**Re: Review of two Air Quality Assessments for the  
planning applications 17/4277M and 17/4034M,  
both for the proposal of residential developments  
off Chelford Road, Macclesfield.**

<b>Job Code</b>	ZHPCM
<b>Report Ref</b>	ZHPCM Air Quality Assessment Review
<b>Report Type</b>	Air Quality Assessment: Report Review
<b>Client</b>	Henbury Parish Council
<b>Client Contact</b>	Simon Browne
<b>Revision</b>	D
<b>Status</b>	Final
<b>Author</b>	Eleanor Winning, Andrew Green
<b>Reviewer</b>	Hugh Datson, John Bruce
<b>Approver</b>	Ayan Chakravartty
<b>Date of Issue</b>	March 2018

Figure B 1: Location of both proposed developments and Broken Cross AQMA

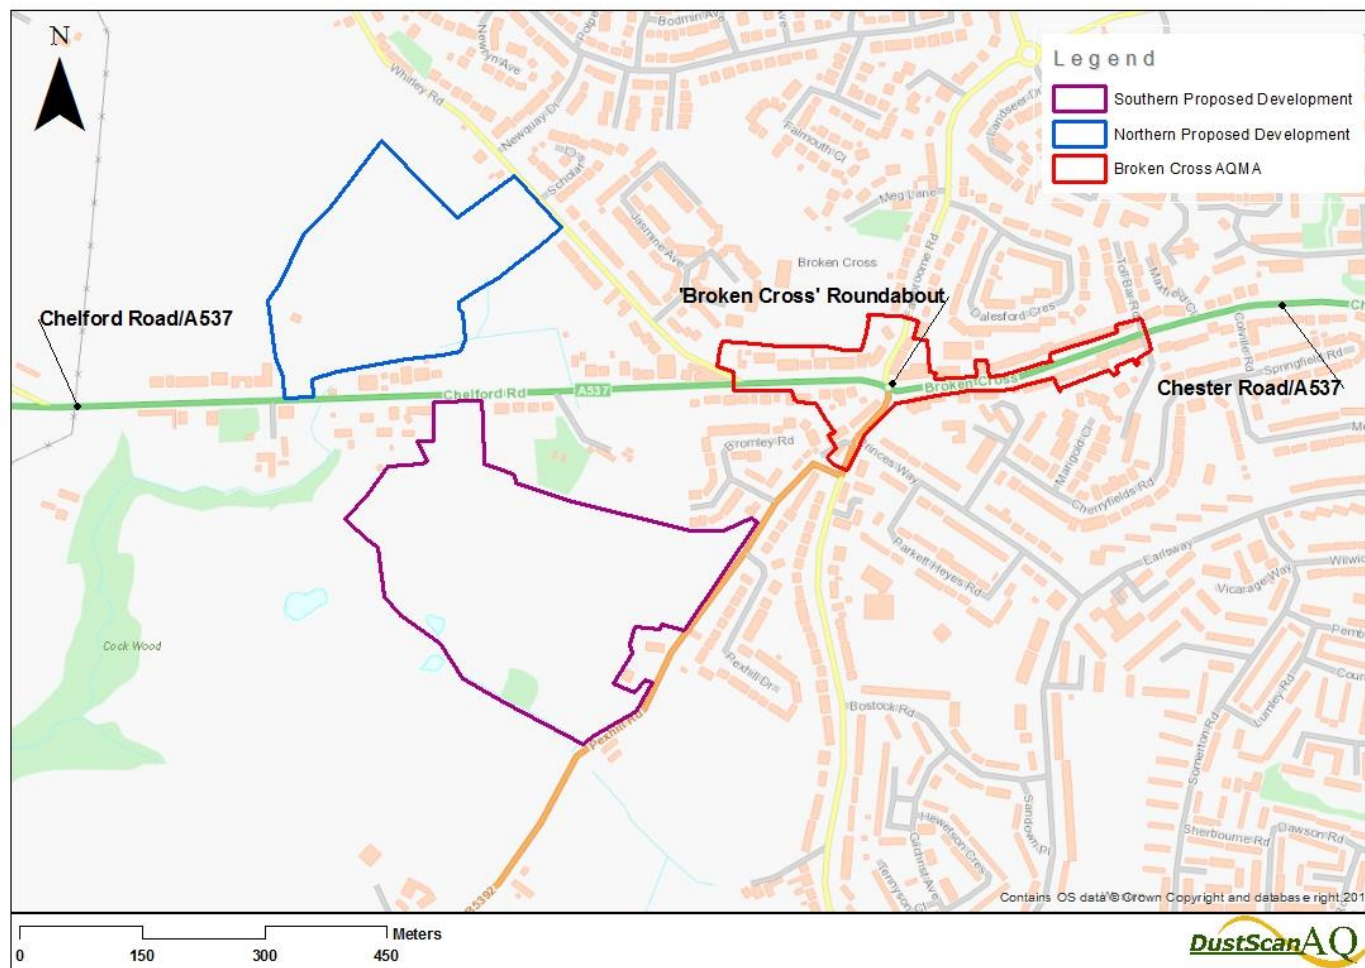
- Assessing potential cumulative impacts on the local area by addressing the proposed development on the south of Chelford Road, which opposite the 'northern proposed development' (Figure B 1);
- Identifying all sensitive receptors along the affected road network from the 'northern proposed development'. The report could have assessed more receptors;
- Assessing potential operational impacts on the Broken Cross AQMA;
- Clarifying the meaning of earliest 'opening year'. It is not clear if the development will be a constructed in a series of phases and if some of the dwellings will be occupied during the opening year or if the opening year implies the start of construction;
- Fully assessing the potential impacts that construction traffic could have on the local area; and
- Stating if there will be an overall significant impact on the local area from the 'northern proposed development'.

- Assessing the potential cumulative impacts on the local area by addressing the proposed development north of Chelford Road and opposite the 'southern proposed development' (Figure B 1);

Figure B 3: Identified sensitive receptors within the Broken Cross AQMA

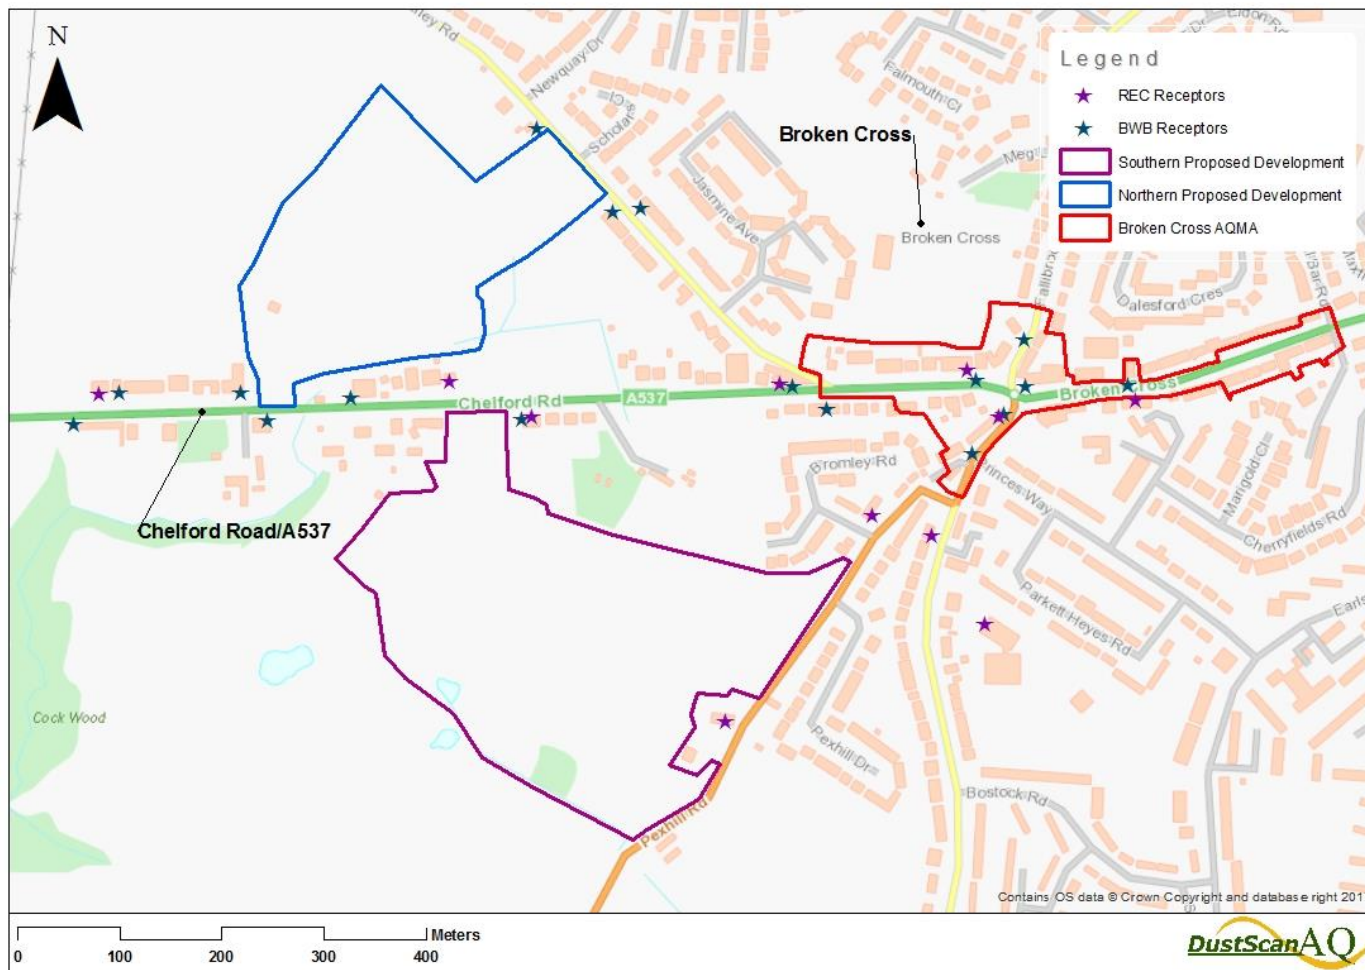
Assessment of potential operational impacts on the Broken	Section 5.2 and Appendix 1	<p>IAQM Planning Guidance:</p> <p>Section 6.7 states: “<i>...identify...the location of atmospheric pollution and</i></p>	<p>Figure B 6 presents the receptor locations presented in the REC report. Figure B 3 clearly shows there are further potential sensitive receptors within the Broken Cross AQMA which were not identified in the REC</p>	<p>The REC report should clearly assess the potential operational impacts from the proposed development on the Broken Cross AQMA. This can be done</p>

Comparison	Comment	Recommendation
<p>Predicted NO<sub>2</sub> concentrations at identified sensitive receptors</p>	<p>Both AQAs predicted NO<sub>2</sub> concentrations at the earliest opening year 'with' and 'without' the proposed development.</p> <p>Figure B 3 presents that many of the BWB AQA modelled receptors are in similar locations to the modelled receptors within the REC AQA.</p> <p>However, Table 6.4 in Section 6 within the BWB AQA and Table 20 within Section 5.2 of the REC AQA present very different NO<sub>2</sub> results for modelled scenarios at identified sensitive receptors. Although future year predictions may vary according to the year of prediction, differences are still significant. This led to differences between the AQAs in determining the magnitude of impacts at some receptors which were situated next to each other.</p> <p>The most likely reason for the differences in predicted NO<sub>2</sub> concentrations is due to different model inputs being used in each AQA including traffic, meteorological and monitoring data.</p>	<p>Both AQAs should review their dispersion modelling, using the most representative data available for all model inputs.</p> <p>Manchester weather station should be used for meteorological data and diffusion tube data from within the Broken Cross AQMA (e.g. CE91) should be used for baseline monitoring data, as these are the closest and most representative sources of meteorological and background data. This data should however be used with caution as HPC have highlighted that data from this site for 2014 may not be representative due to possible mishandling and reporting of data. Both reports have identified receptors close to the CE91 NO<sub>2</sub> diffusion tube (see Figure B 3 and Figure B 4).</p> <p>Further to this, as previously stated in Table A 1 and Table A 2, an additional modelling scenario should be undertaken to assess the cumulative impacts on identified sensitive receptors. This should be undertaken using data from the meteorological and background concentration sources stated above, as well as using cumulative traffic data.</p>

Figure B 5: Proposed roundabout at the site entrance on Chelford Road from 'southern proposed development'

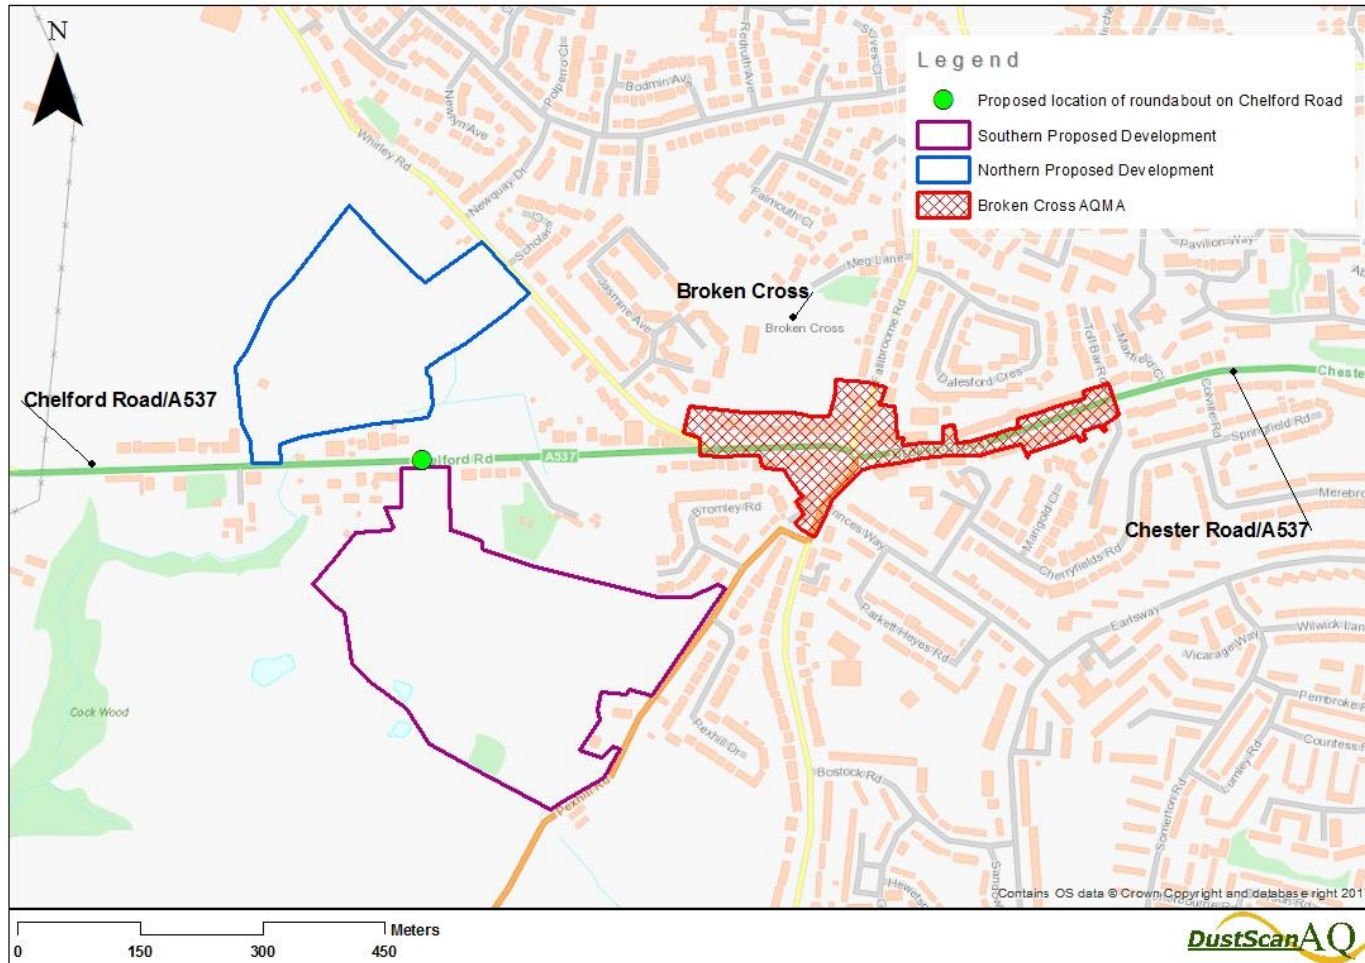
- Fully assessing the impact of construction traffic from the proposed development site on the local area;
- Including the proposed development of a roundabout at the site entrance and what impacts this would have on traffic flow and modelled emissions;

Additional Information	Report	Comment and Recommendation
<p>A transport statement was submitted by CBO on 21 August 2017 to HPC as part of planning application 17/4034M. The transport statement proposes the development of a roundabout on Chelford Road at the site entrance of the proposed development (Figure B 5).</p>	<p>BWB</p>	<p>If planning permission was granted to both planning applications, due to the location of the proposed roundabout (Figure B 5) as part of 17/4034M planning application, it would impact traffic flows and therefore traffic emissions from the 'southern proposed development' associated with planning application 17/4034M and the 'northern proposed development' assessed in the BWB AQA.</p> <p>The BWB AQA was submitted 8 days before the transport statement on 29 August 2017 in relation to another planning application, 17/4277M. Therefore, it is unlikely that BWB were aware of this proposed change to the road layout adjacent to the proposed development. With this new information now available, the BWB AQA needs to be revised by assessing the potential impacts the changes in the road layout could have on the traffic flow and emissions from the proposed development on the local area.</p>

<p>REC</p>	<p>The REC AQA should identify the proposed change in the road layout at the proposed development site entrance on Chelford Road (Section A.2, Table A 2).</p>

**Figure B 7: Proposed changes to the road layout at the Broken Cross roundabout**

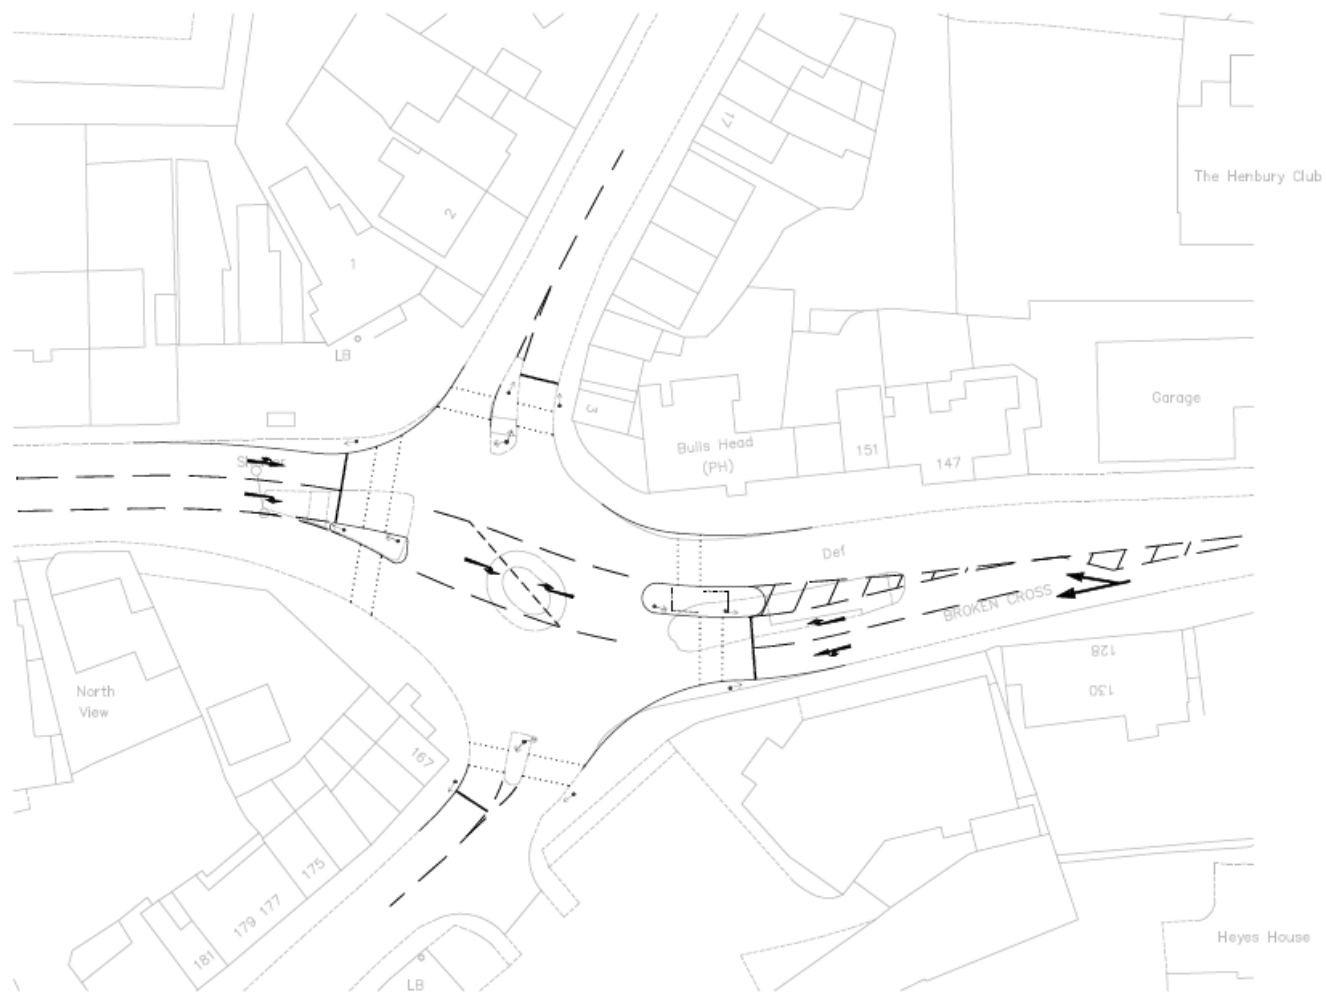
It is understood that the current roundabout at Broken Cross is at or close to capacity during peak times. The proposed signalised junction may help to reduce queue lengths during peak times but could also have a negative impact on other times of the day and potentially create pollution hotspots at signals. Further work should therefore include justification for how the new junction signals will impact air pollution hotspots in the AQMA both at peak hours (by reduction in queue lengths) and at non-peak hours where queues may be longer.

Additional Information	Report	Comment and Recommendation
<p>Submission of a design, access and supporting statement<sup>9</sup> which included additional highways information on 06 February 2018 for planning application 17/4034M. The information included proposed changes to the Broken Cross roundabout if planning application 17/4034M was accepted.</p>	<p>BWB and REC</p>	<p>The submission of a change in the road layout would be on a stretch of road that would be used by traffic from both northern and southern proposed developments considered in this review (Figure B 7). However, this proposed change to the Broken Cross roundabout was submitted after the submission of both AQAs, thus was not considered in either AQA.</p> <p>Therefore, it is advised that both AQAs are revised and assess the potential impacts that the change in the road layout at Broken Cross would have on traffic flow and traffic emissions on sensitive receptors. This should include modelling scenarios presenting potential cumulative impacts on the Broken Cross AQMA.</p>
